**MAIN OFFICE RENOVATIONS
BERKS COUNTY INTERMEDIATE UNIT**

2.9 The following attached Sketches and Drawings dated 10.30.25 are hereby issued with this Addendum:

END OF EMAIL ADDENDUM NUMBER TWO

REVISED ROOM FINISH SCHEDULE.

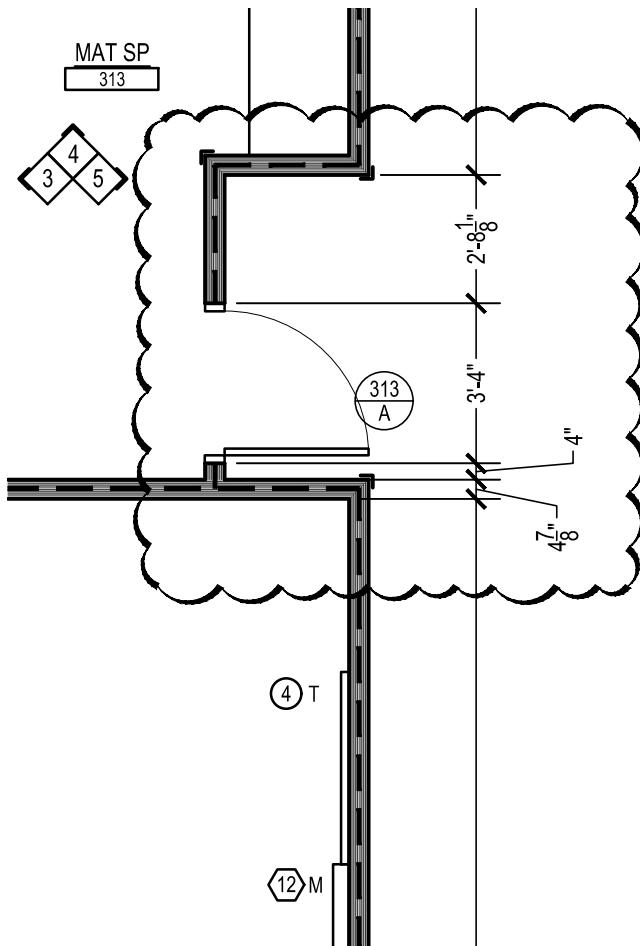
2.17 Drawing A-17 & A-18 – Room Finish Schedule – Main Office and Reading Crest

- A. Add "Note 1" in the remarks column for the following spaces:

- Room 220B
- Room 231
- Room 232C
- Room 232E
- Room 234L
- Room 305

- B. The column labeled "Sheet Vinyl" under "Floors/Materials" shall be changed to "Resinous Flooring."
- C. At both locations for the General Notes in the schedule, add the following Note:
 - For bidding purposes, all areas to receive new flooring shall be assumed to be provided cementitious underlayment at a thickness of 1/4-inch.

ROOF WARRANTY

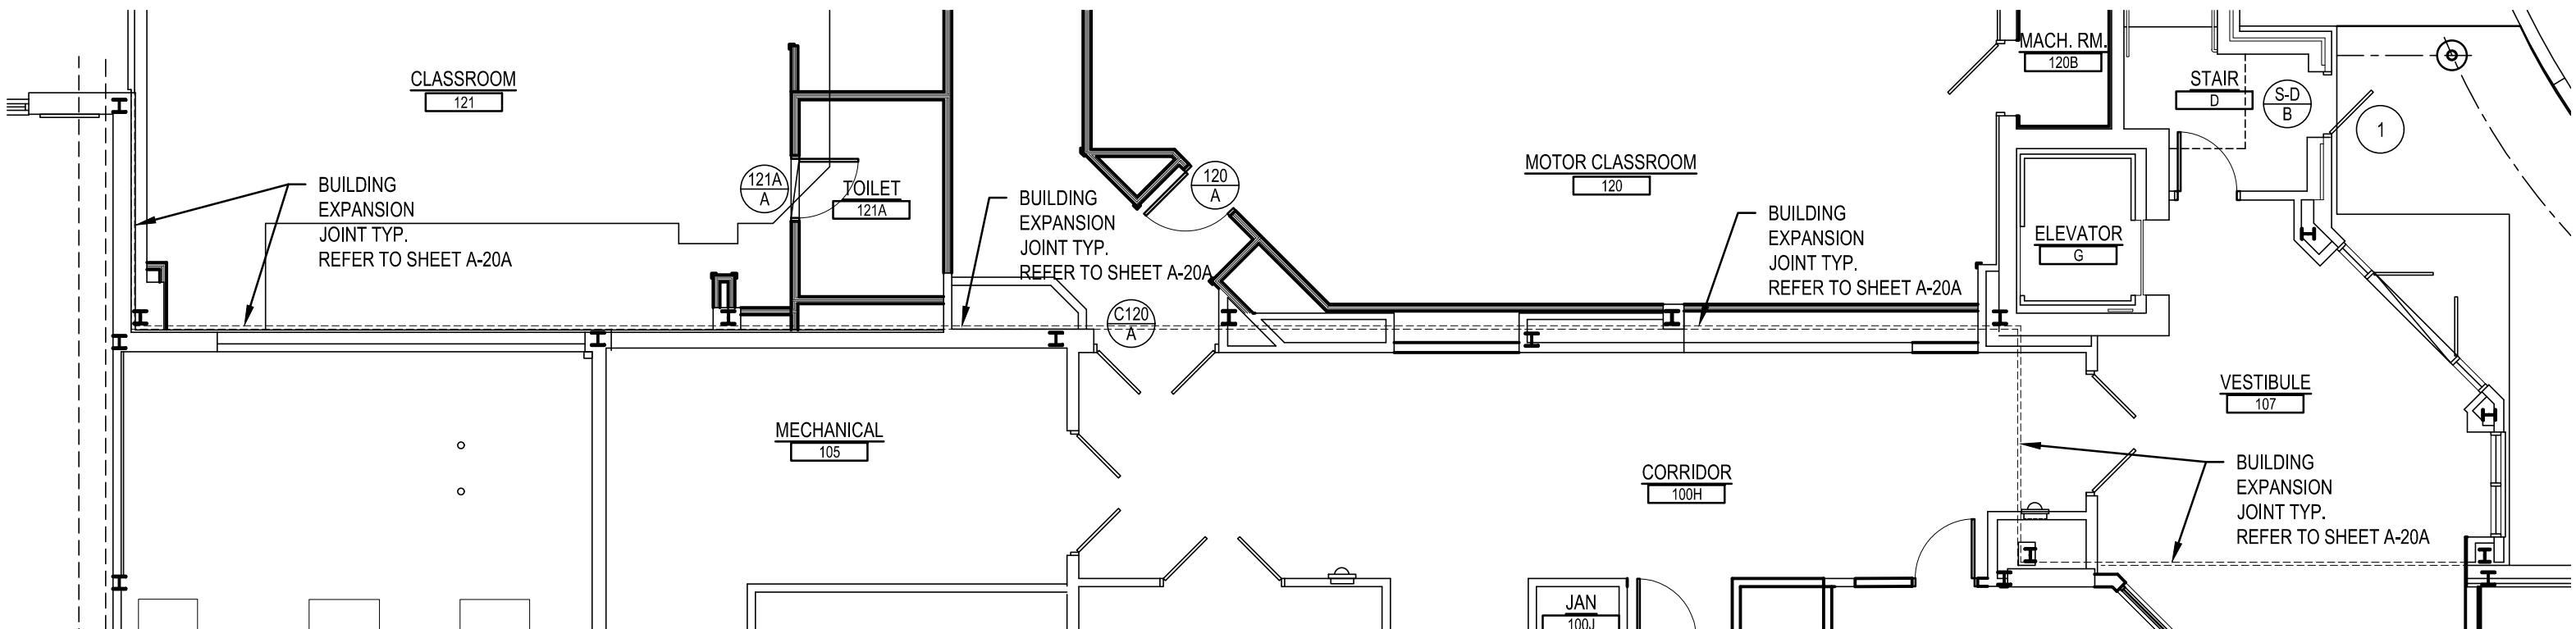
The existing roofs are Carlisle and Johns Manville warranted systems and work provided shall be by one roofing subcontractor that meets the above certification requirements for both manufacturers. No other manufacturers will be considered. A keyplan will be issued in Addendum No. 2 showing areas of warranted roofing systems.

DATE: 10.30.25
 DRAWN BY: AJO
 SKC-2

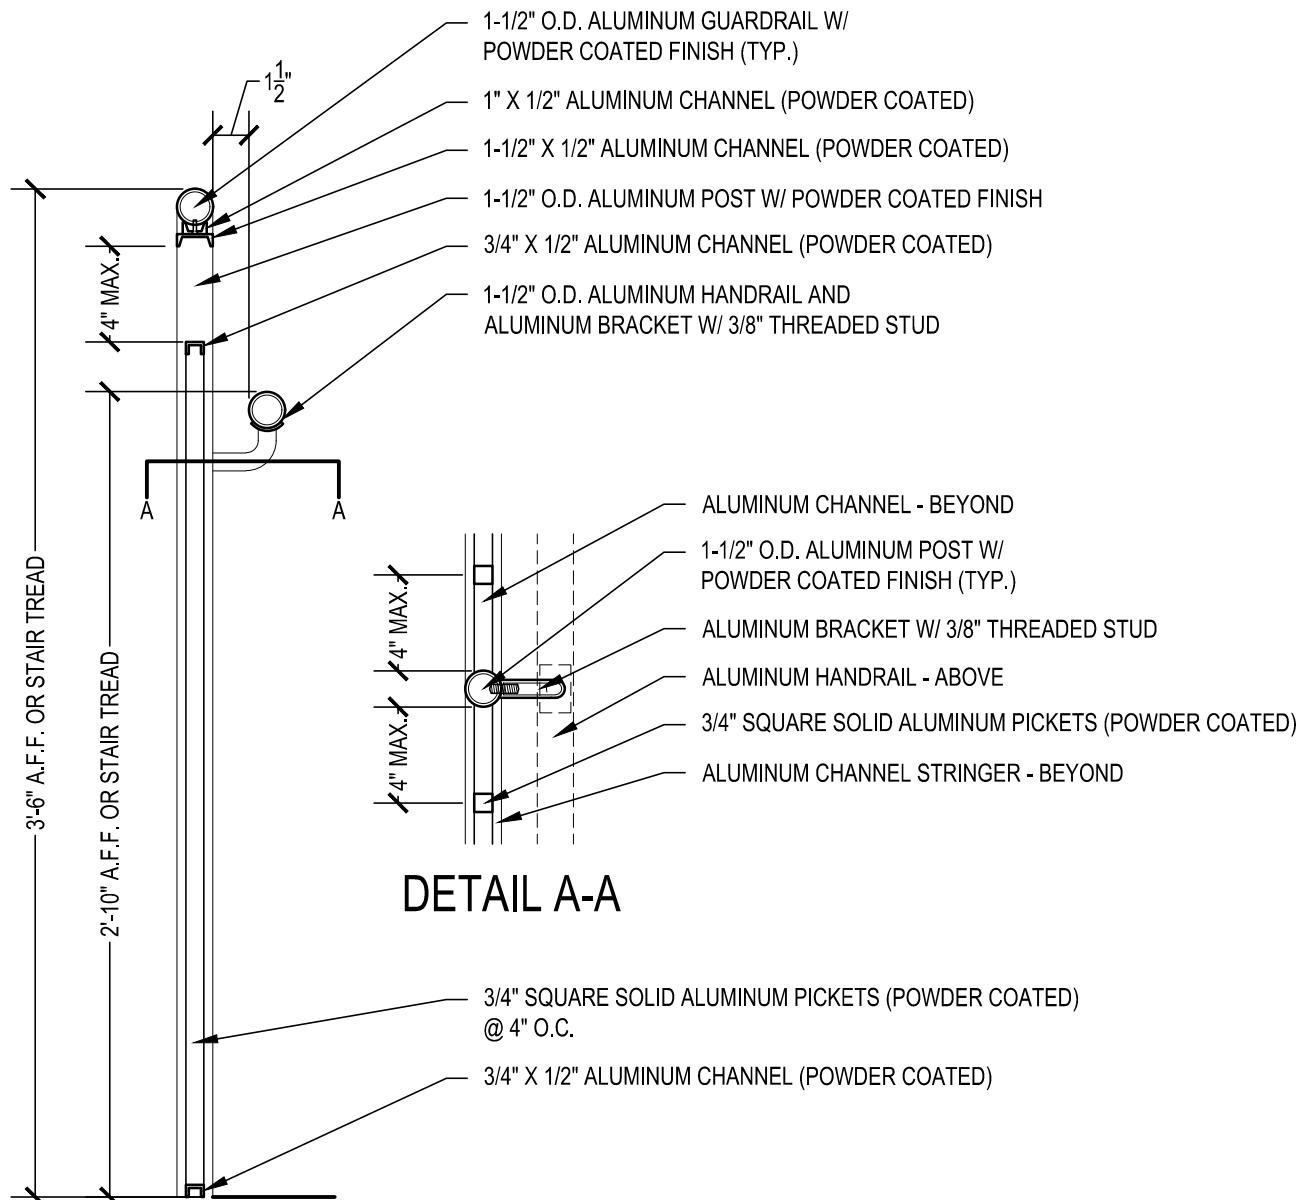
<u>Sketch</u>	<u>Reference</u>	<u>Description</u>
SKC-2	C-3	Asphalt Diversion Berm
SKC-3	C-5	Revised Detail to Picket Guards
SKC-4	C-7	Paving Reconstruction
SKC-5	C-6	Stair Tower Exit Door
SKA-5	A-12	Added Lights to Corridor 100E, Room 100F High NRC Acoustical Ceiling Tile
SKA-6	A-17	Revised Room Finish Schedule
SKA-7	A-17	Revised Room Finish Schedule
SKA-8	A-A6 & A-A7	Revised Dimensions for Door Alcoves to Room 312 & 313 and Kitchen 320B Chase
SKA-9	A-11	Roof Warranty
SKA-10	A-A1 & A-C1	Building Expansion Joint Location
SKA-11	A-A2 & A-C2	Building Expansion Joint Location
DWGPH-1	—	Building Phasing Plan
DWGA-2	—	Code Notes
DWGA-3	—	Code Plans

REVISED DETAIL TO PICKET GUARDS

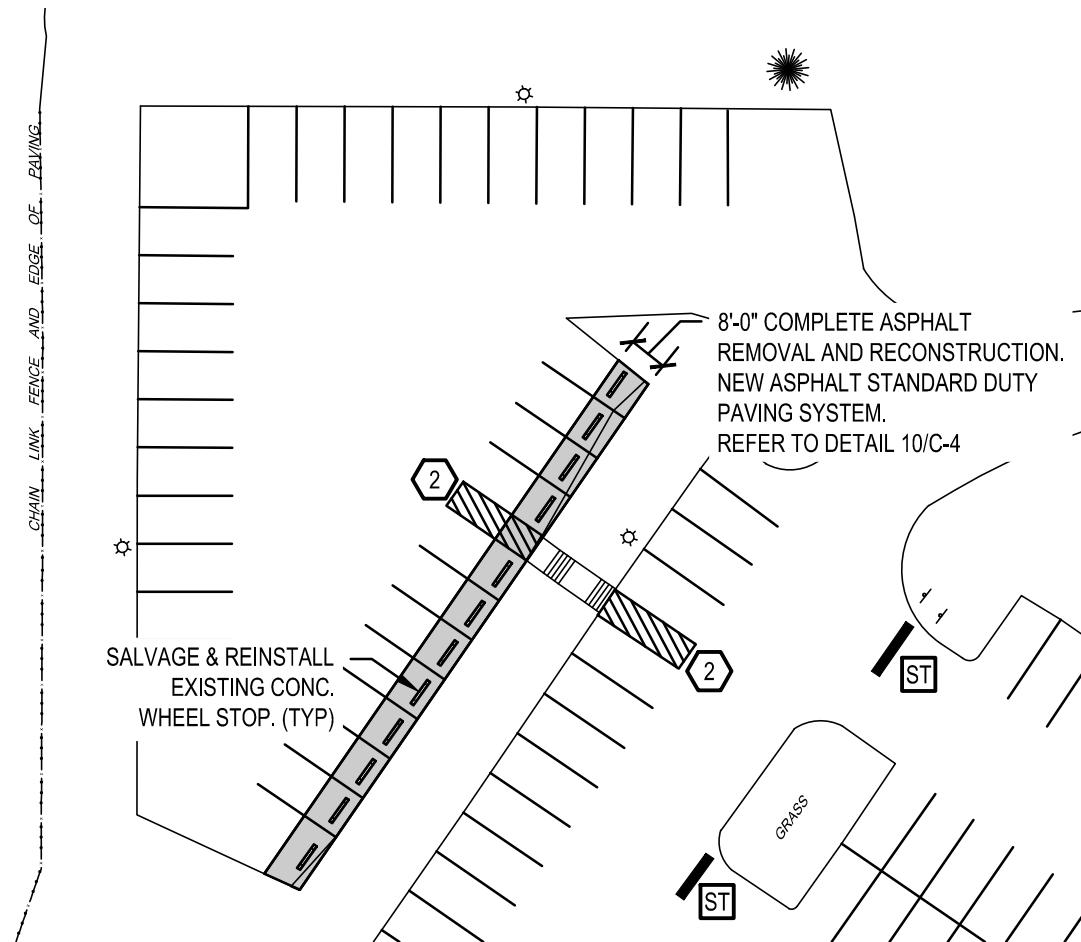
- A. On "Exterior Elevations 2," the reference to "New Railings" at the right end of the building shall be changed to "Railing – Refer to Detail 11/C-5."
- B. On "Partial Exterior Elevation 6," remove the reference to Note 13 in a diamond.
- C. On "Exterior Elevation 1," on the far-right side of the elevation on the rightmost first-floor window, remove the reference to Note 6 in a square.
- D. In the "Masonry Restoration Notes," Item K shall reference Drawing A-20A, not A-24.
- E. In the "Keyed Elevation Notes," Note 6 shall be modified to read as follows: "Replace Existing Spandrel Glass with Clear Insulated Glazing Unit."
